## SERVICE BULLETIN

#0017

**SUBJECT:** Potential risk of shearing of control stop plate rivets

**MODELS AFFECTED:** Sling 4 and Sling 4 TSi aircraft

Figure 1 - Elevator control torque tube for Sling 4 and Sling 4 TSi aircraft

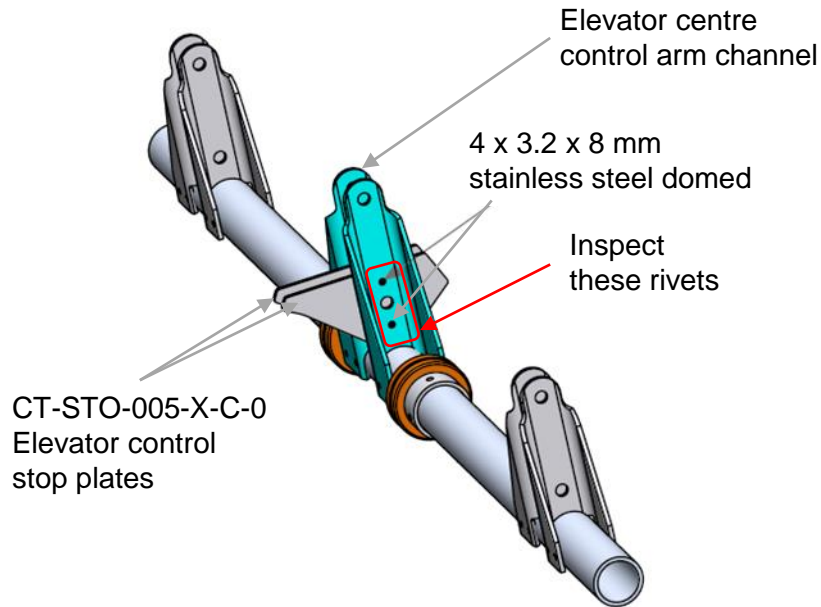
1. The rivets on the torque tube that need to be inspected are shown in Figure 1. The control stop plates (CT-STO-005-X-C-0) and elevator centre control arm channels are also shown in Figure 1.
2. Remove a front seat from the fuselage then use the 2 mm / 2.5 mm Allen key to remove the floor skin (refer to CF-SKN-016-R-C-0) shown in Figure 2.
3. The inspection region when the floor skin is removed is shown in Figure 3. Use the light source to determine if control stop rivets are aluminium or stainless steel. Use Figure 4 as a guide for making the distinction.
4. Alternatively (or in addition to using the light source) use a magnet to identify rivets. The mandrel of the aluminium rivet used is magnetic, so a magnet will attract to the aluminium rivet (see Figure 4).

Figure 3 - Region of inspection area and seat rail

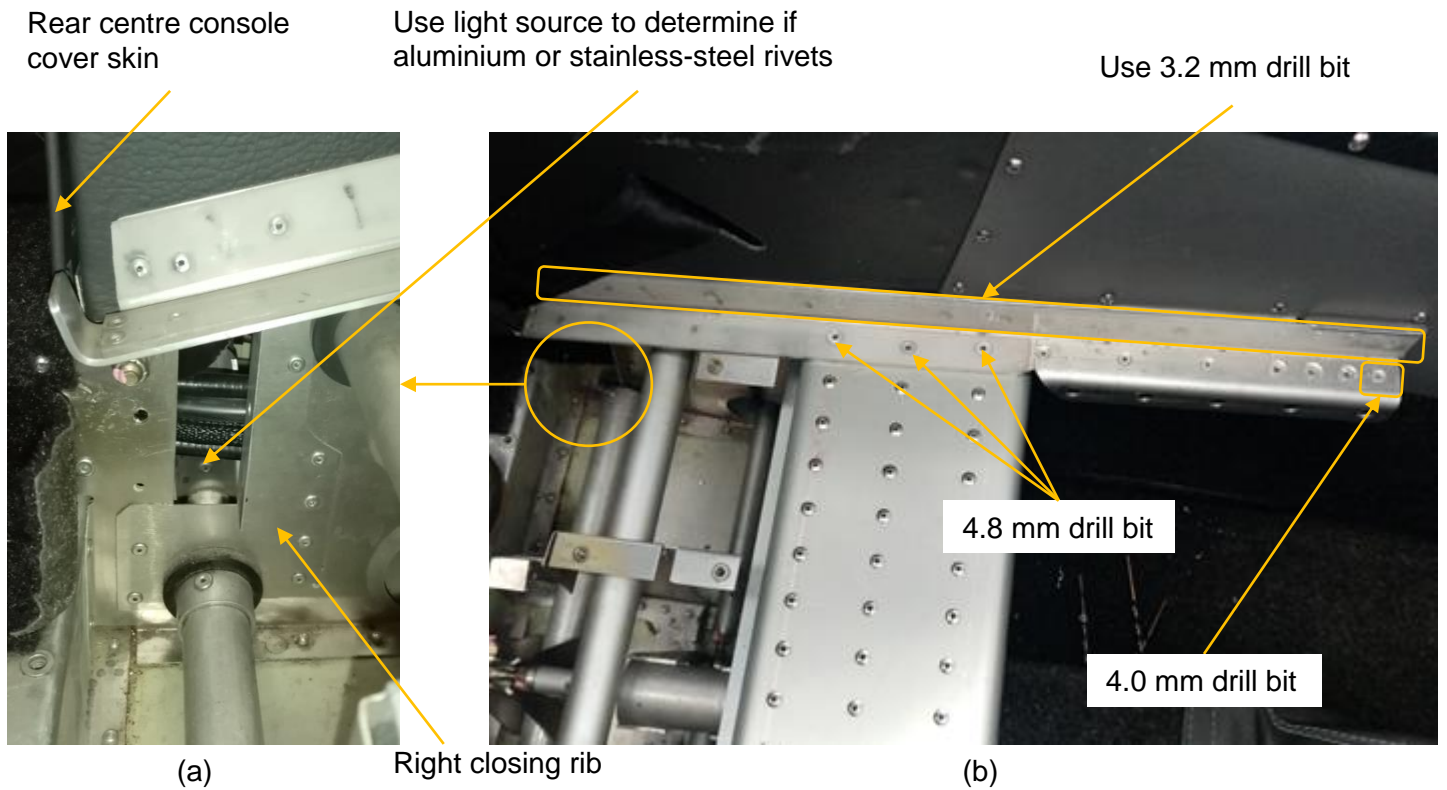
7. Drill the heads off the countersunk rivets shown in Figure 3(b) with the angle drill (using 3.2 and 4.8 mm drill bits) to remove seat rails.
8. Remove and retain all M3 / M4 screws on the aft section of the centre console to separate it from the forward section as shown in Figure 5(a).

11. Cut the cable ties that guide the centre console wiring and pitot static tubes (using the side cutter) to reduce their tautness, then use the angle drill and 3.2 mm drill bit to drill heads off the rivets on the closing rib as shown in Figure 5(b). The closing rib on the centre console RH side is shown in Figure 3(a).

17. The AN4 lock-nuts (hardware designation AN365-428A) must be tightened such that the seat belt brackets can still swivel.
18. Install the controls closing ribs (CF-RIB-009-R/L-C-0 shown in Figure 3(a)) using the 3.2 mm clecos to align the holes. Assemble with (20) 3.2 x 8 mm aluminium domed rivets.

20. Return the seat rails, including the plastic plates, using clecos to align the holes before riveting. Use the hand riveter, two 4.0 x 10 mm and six 4.8 x 15 mm countersunk aluminium rivets to assemble the seat rails. In addition, install the (18) 3.2 x 10 countersunk aluminium rivets on the upper rails (see Figure 3(b)).
21. Return the rear centre console cover skin and the floor skin shown in Figure 3(a).
22. Any dome head cap screws experiencing resistance during assembly should be cleaned with an M3 / M4 thread tap (tap size depending on year model).

Figure 5 – Disassembly of centre console and removal of CF-RIB-009-R/L-C-0

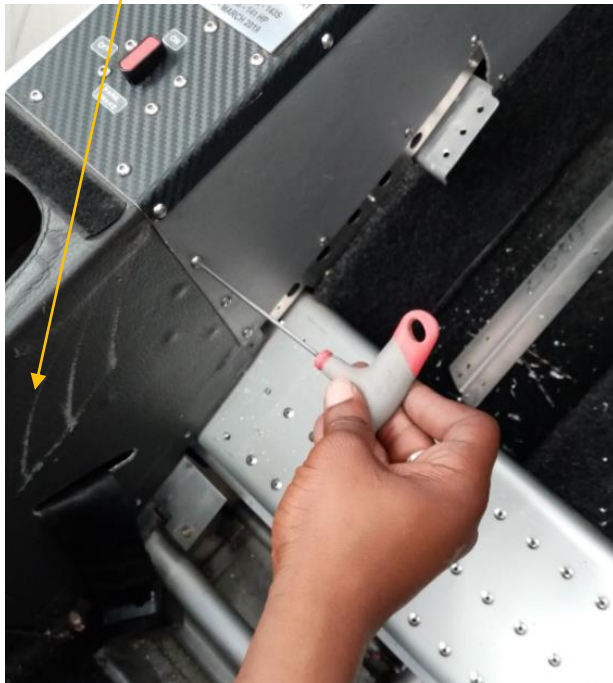
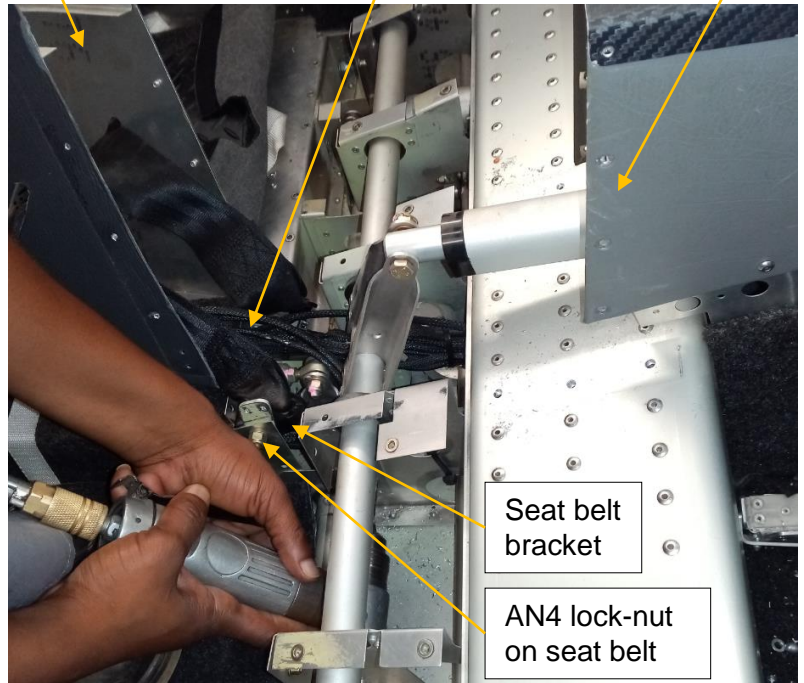
9. The aft section of the centre console must be carefully pulled away so as not to damage wiring and pitot static lines running through the console as shown in Figure 5(b). If resistance is felt separating the aft and forward centre console sections, the headset jacks should to be removed with the 14 mm spanner and socket. Be sure to label these cables left and right so that they are refitted in their original positions (see Figure 6).

12. Use the 7/16" spanners to loosen the AN4 lock-nuts (hardware designation AN365-428A) on seat belt shown in Figure 5(b) so that the seat belt bracket can swivel. This will ensure there is sufficient room for the hand riveter to be pressed firmly against elevators' centre control arm channel when installing the 3.2 x 8 mm stainless steel rivets (See Figure 7).

19. Return the aft section of the centre console using the 2 mm / 2.5 mm Allen key and install the M3 / M4 screws (see Figure 5(a) which shows disassembly).

Figure 7 – Installation of stainless steel rivets

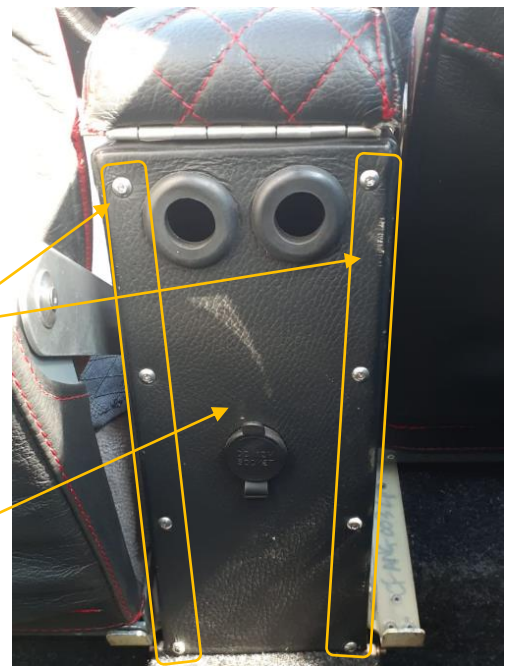
13. On the control stop plate, remove the aluminium rivet and install the 3.2 x 8 mm stainless steel rivet. Apply this remedy one rivet at a time to prevent the control stop plate from detaching from the control tube.

14. Be sure to press the hand riveter firmly against the elevators' centre control arm channel so that the rivet "catches".
